# ONE SYDNEY HARBOUR

BARANGAROO

R4B SUPPLEMENTARY DESIGN STATEMENT FOR S4.55 MODIFICATION APPLICATION  
June 2021

Proposed Ground Floor Plan

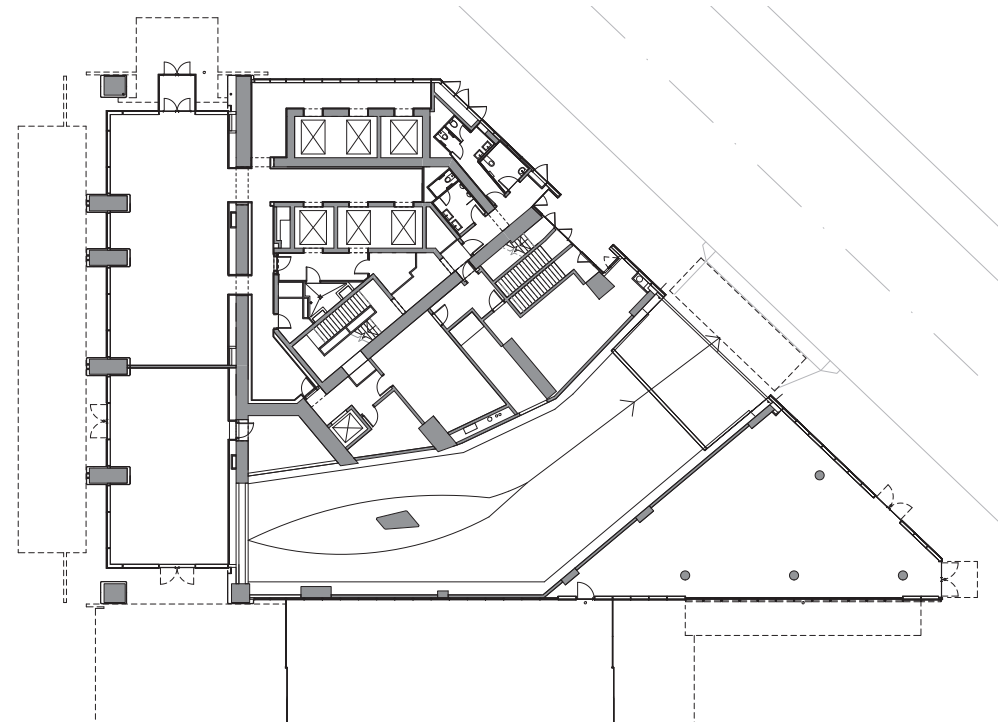
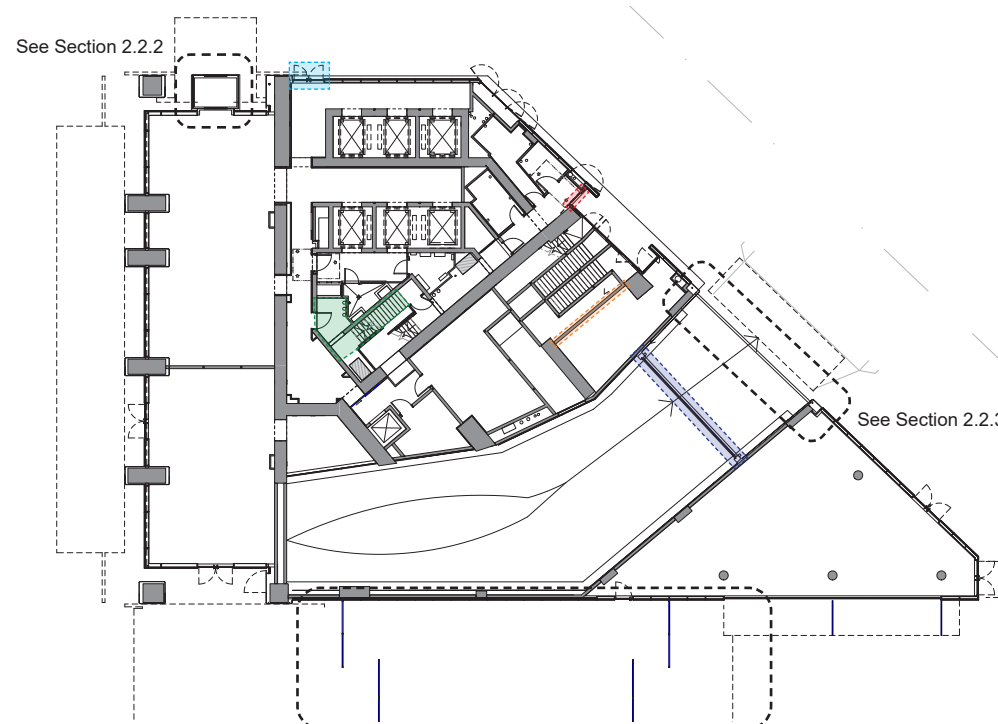
Minor changes are proposed for the ground floor and level 1 floor plans. These changes are predominantly a response to building compliance reviews that has occurred through design development (such as the provision of second egress pathways), design developments (such as the fine tuning of the car park entry ramp door location) and general design improvements.

- Addition of a secondary lobby exit (double pivot doors)
- Entry modified to adopt a sliding door system
- Wall added for new stair pressurisation plant
- Carpark entry ramp door location fine tuned
- Egress pathway added and store room removed
- Second egress added to mezzanine plantroom
- Door adjusted, amenity stairs adjusted, store room removed

Proposed Level 02 Floor Plan

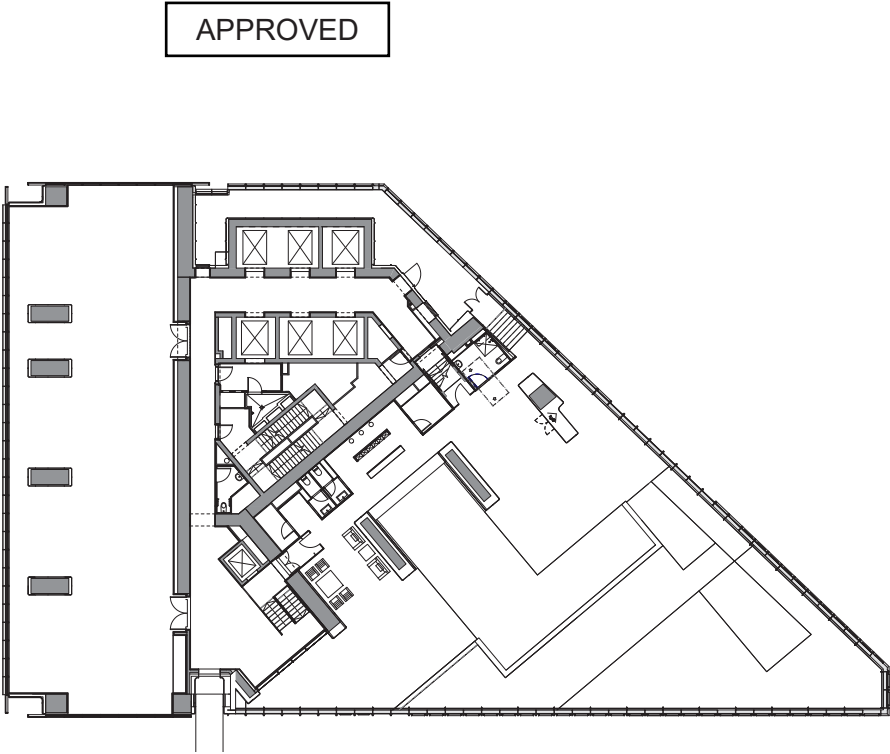
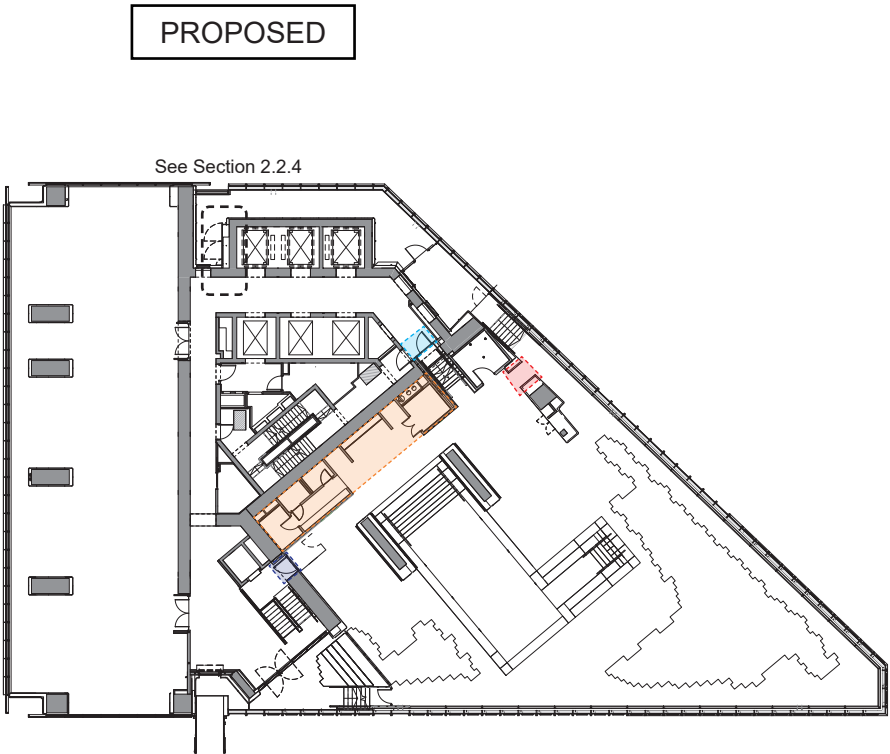
Changes to the Level 02 floor plan include minor improvements to the bathing amenities layout, the width and alignment of the portal highlighted in red, and changes to the door types in the highlighted accessways to the swimming pool terrace.

-  Sliding door changed to swing door
-  Facade updated
-  Shower area and amenities changed
-  Double door changed to single door

Proposed Entry vestibule - Plan

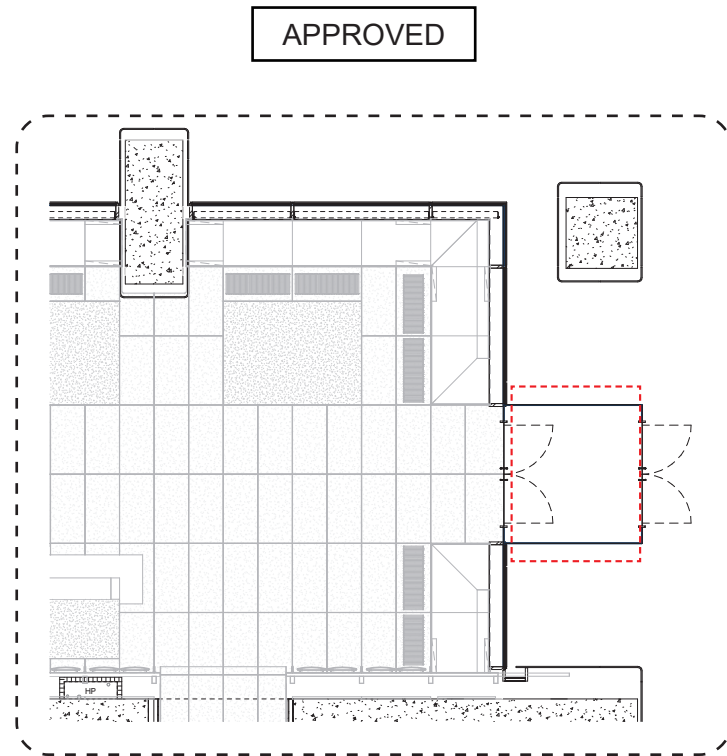
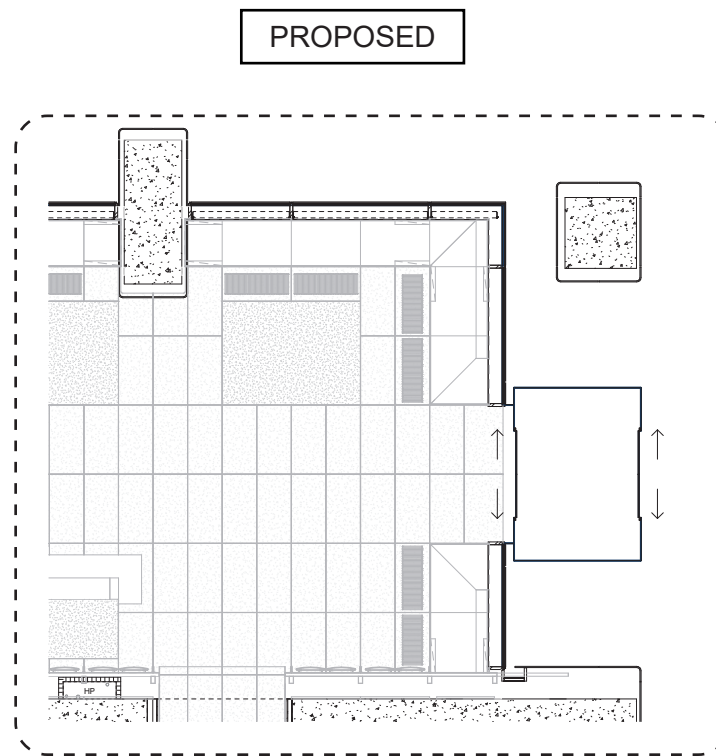
Automated sliding doors have been integrated in lieu of swing doors, improving operability as well as creating a seamless transition from outside to the residential lobby interior.

Through detailed review with the project consultant team, it has been determined that a sliding door system would provide a more robust, reliable and fit-for purpose solution.

This amendment has resulted in a minor adjustment to the dimensions of the lobby vestibule. This amendment has been integrated into the modulation, proportion and geometry of the facade to provide a design response that meets the design standards of the precinct architecture.

Proposed Entry vestibule - 3D View

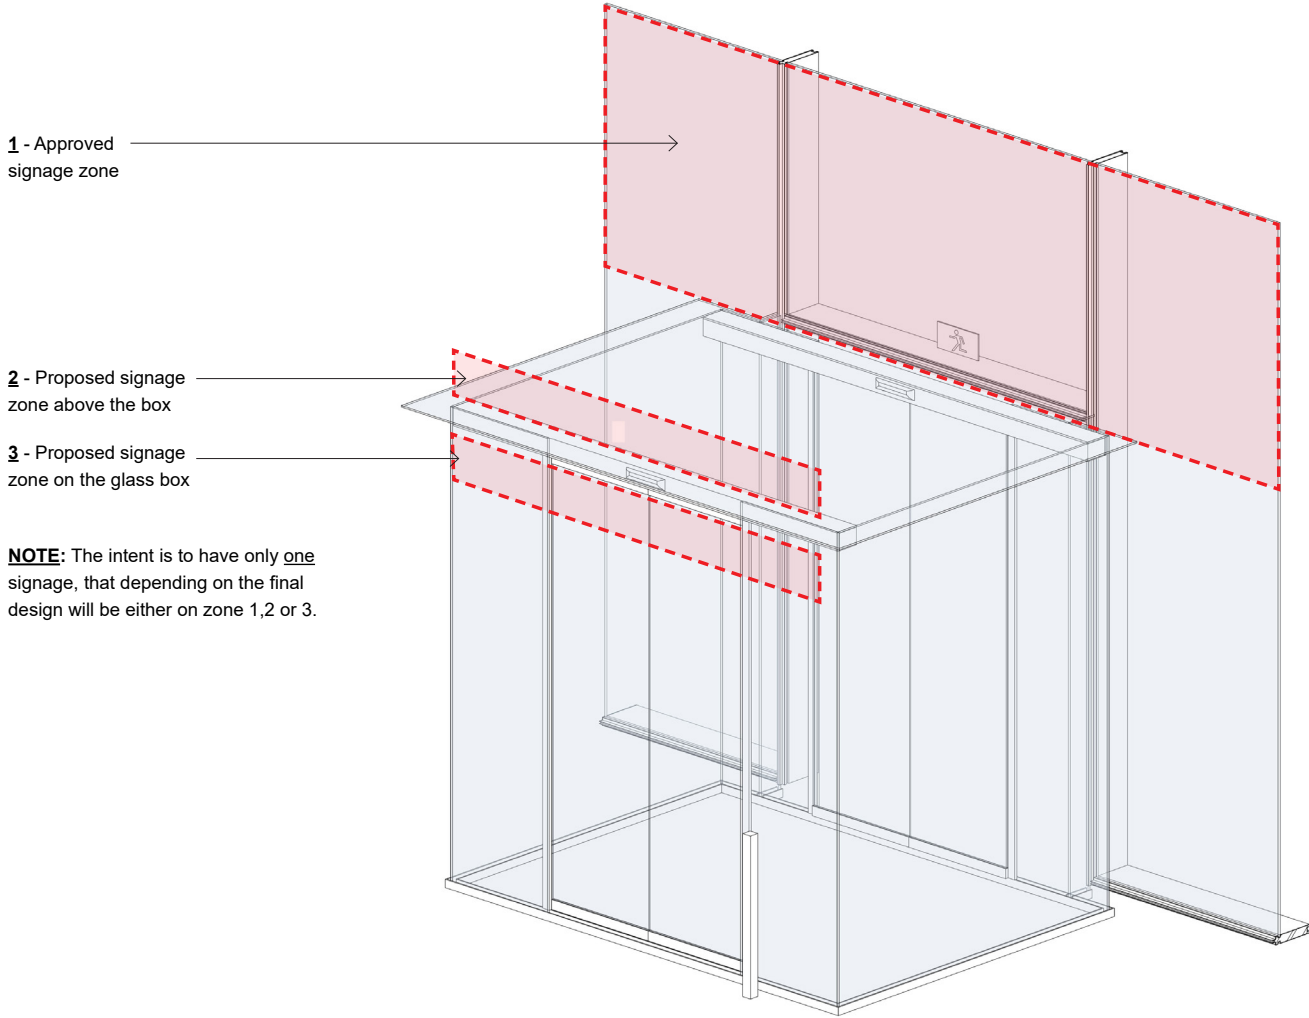
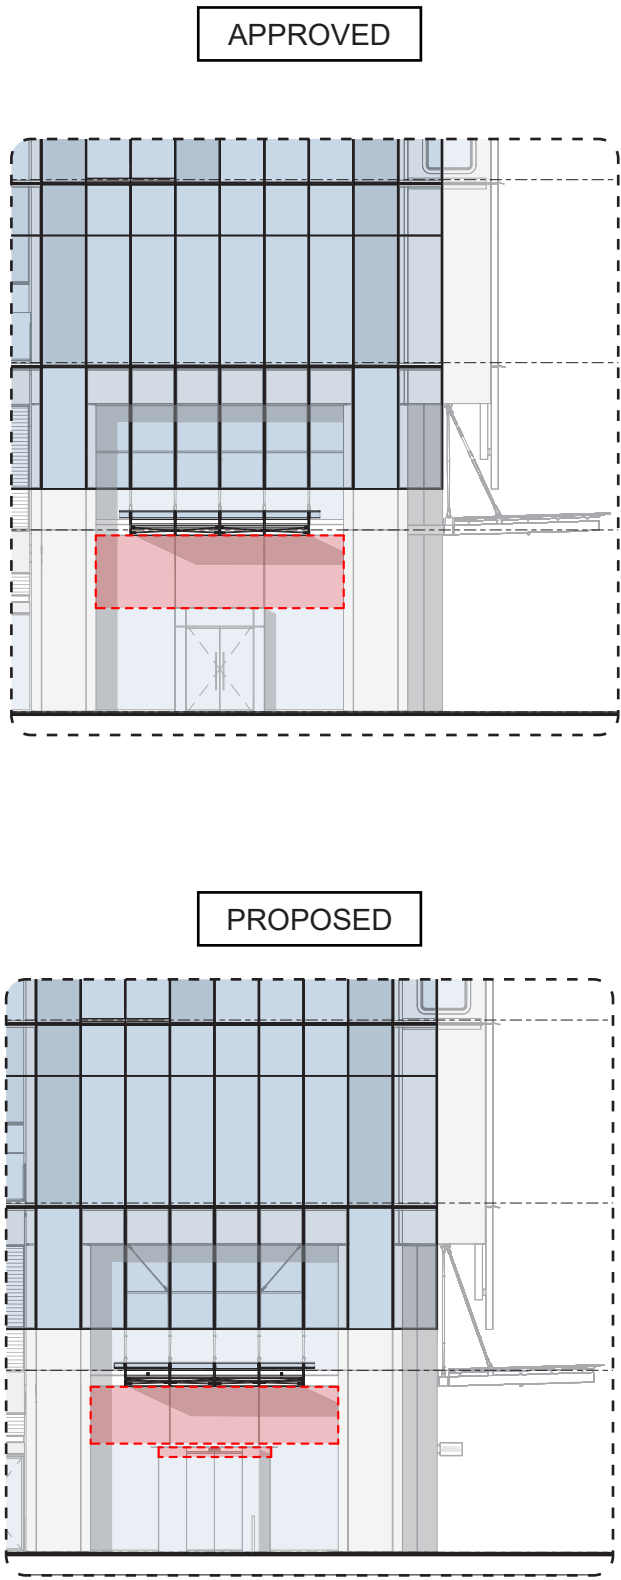
Further detailed development on building signage has been undertaken and it is proposed to revise the location of the entry vestibule signage zone as shown on the right.

The already approved zone above the entry vestibule box has been extended to include a potential signage on the glass above the door. Depending on the final design the signage may be located either on the glass or above the vestibule volume.

**NOTE:** The intent is to have only one signage, that depending on the final design will be either on zone 1,2 or 3.

Proposed P02 Floor Plan and Vent pipe zone Blow-up

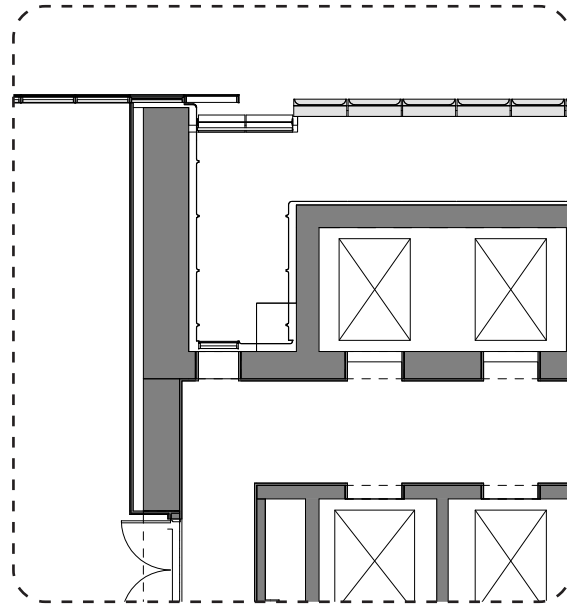
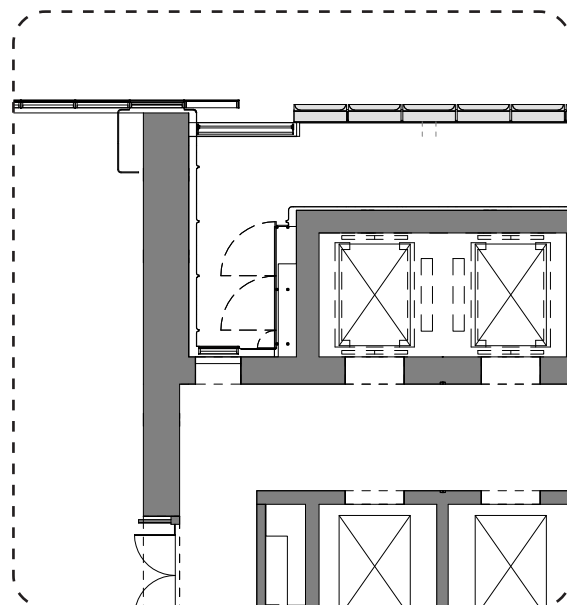
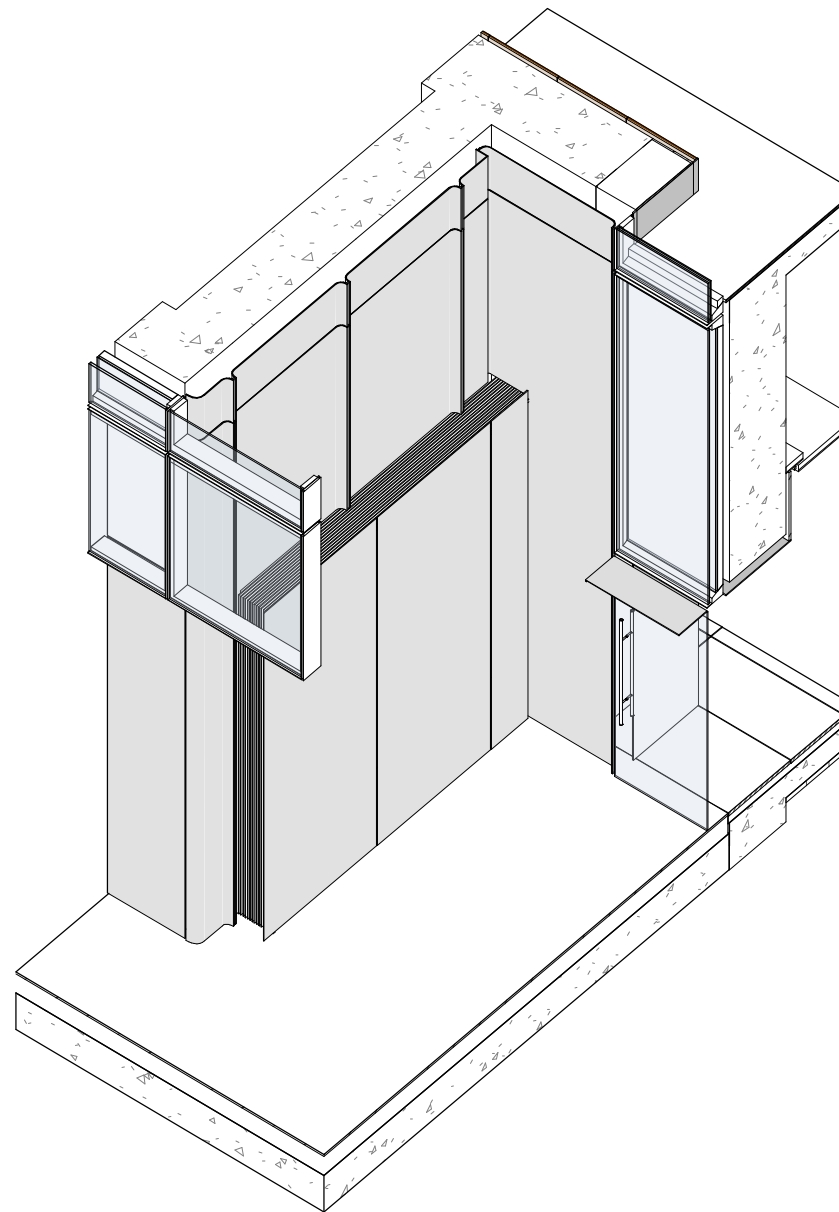
An amendment is also proposed to the vent pipes on P02 level close to the south east lift core facade.

The approved box flue solution was reworked to better reflect the design of the facade. The proposed scheme has the pipes arranged inside a cabinet-like structure, preserving the facade modularity and finishes, resulting in a visually integrated outcome.

This change was also driven by the aim to increase the clear width leading up to the window in that area.
